GROUP Engine	MODEL 2014MY Sorento (XMa) w/2.4L GDI Engine
	NUMBER PS356	DATE October 2014

SUBJECT: HIGH PRESSURE FUEL PUMP AND FUEL LINE COMPATIBILITY

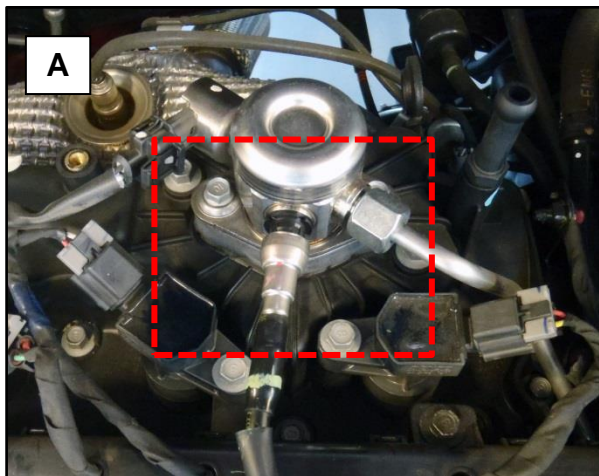
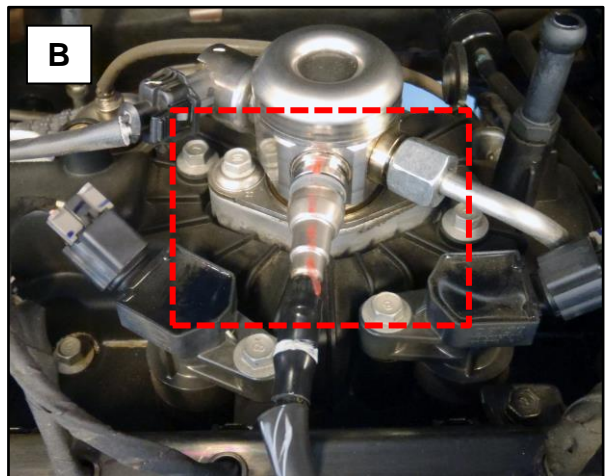
When replacing the High Pressure Fuel Pump of some 2014MY Sorento (XMa) vehicles equipped with the 2.4L GDI engine and produced prior to July 26, 2013, refer to the table below to determine compatibility between the feed tube connector on the end of the fuel line and the High Pressure Fuel Pump, as installed on the vehicle.

High Pressure Fuel Pump P/N	Figure	Remarks
P/N 35320 2G730	A	Black Feed Tube
P/N 35320 2G740*	B	Gray Feed Tube

*Requires P/N 31336 3Z000 (Clip - Fuel Tube)
